ERRATA SHEET

WRIR 86-4358 PLATE 3

HYDROGEOLOGY OF STRATIFIED-DRIFT AQUIFERS AND WATER QUALITY IN THE NASHUA REGIONAL PLANNING COMMISSION AREA
SOUTH-CENTRAL NEW HAMPSHIRE

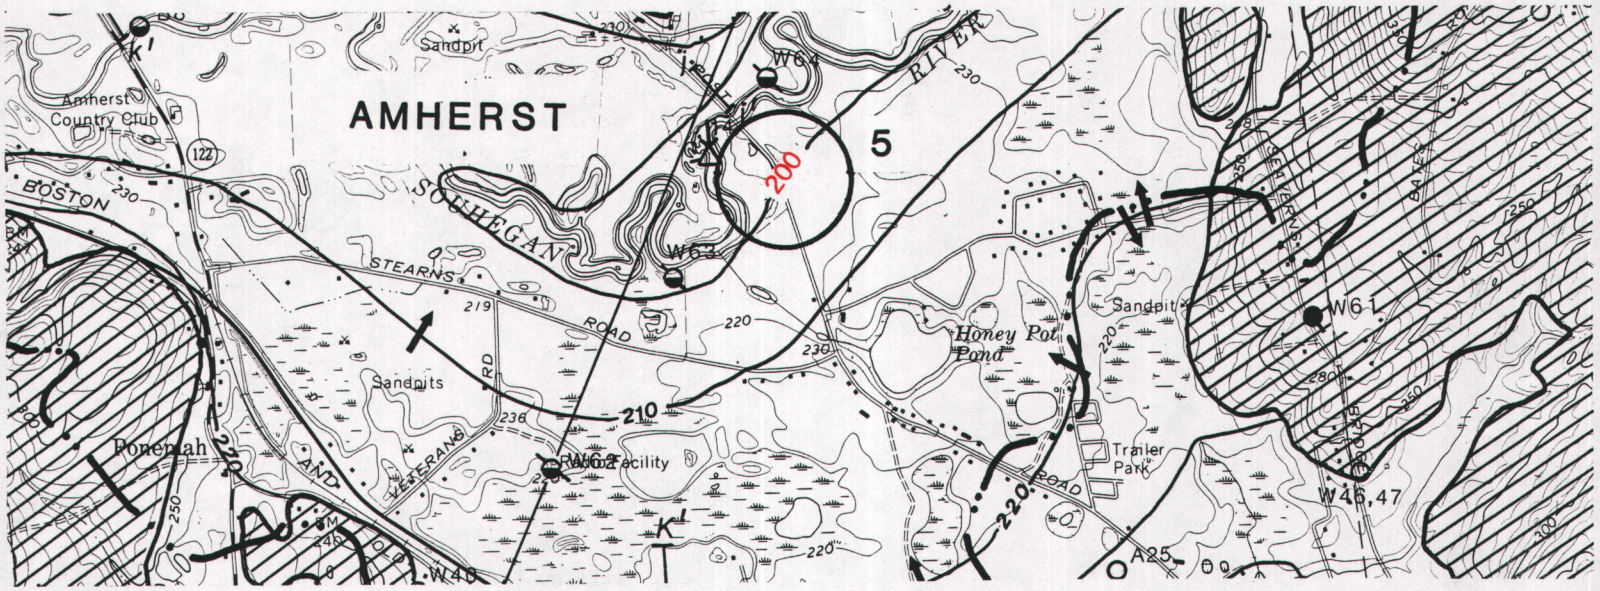
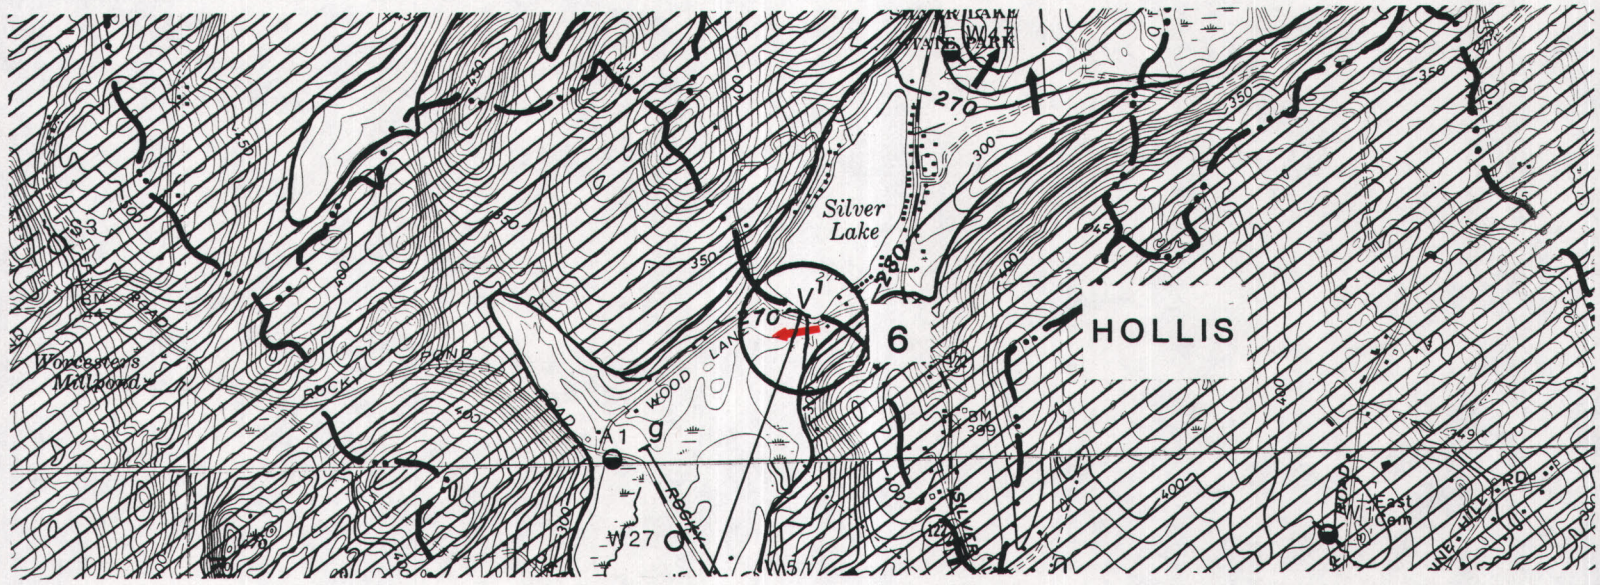
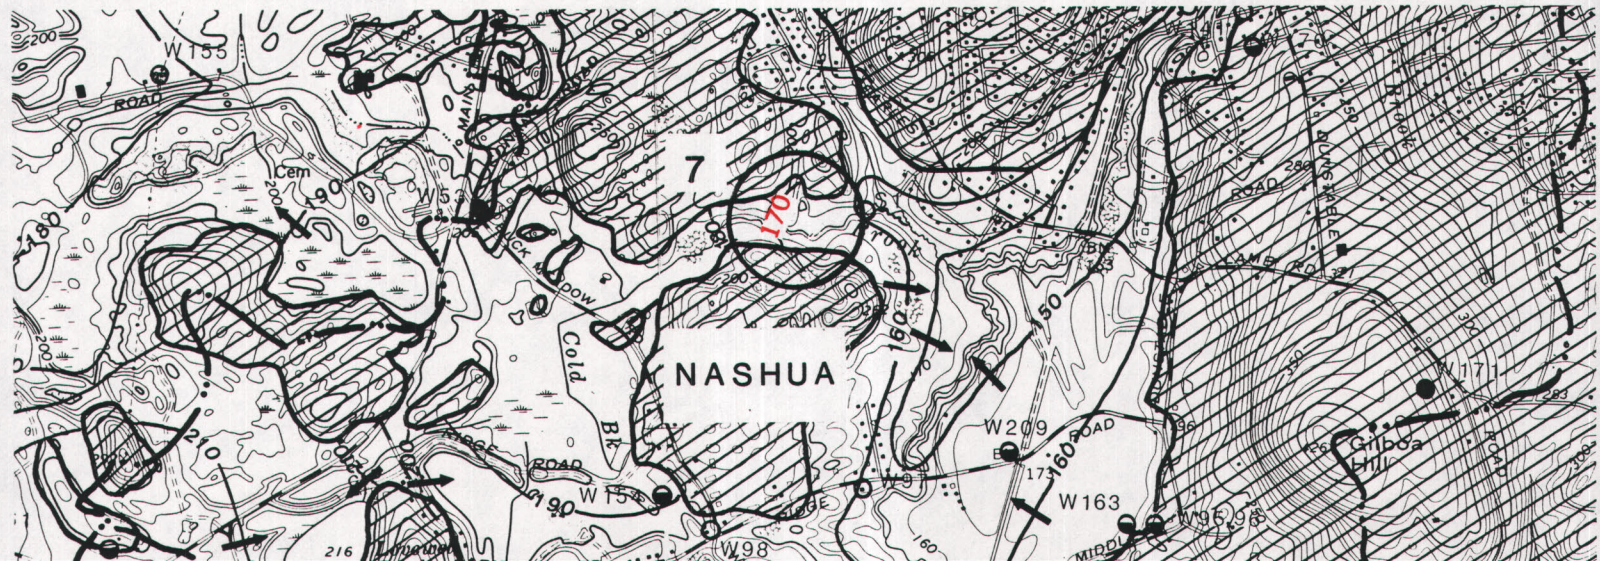
ERROR	TOWN	NEAREST LANDMARK	CORRECTION
5	Amherst	Boston Post Road/ Souhegan River area	Water-table contour 230 should be 200
6	Hollis	Silver Lake	Flow arrow on water-table contour 270, opposite direction
7	Nashua	Cold Brook, southwest Nashua	Water-table contour 190 should be 170
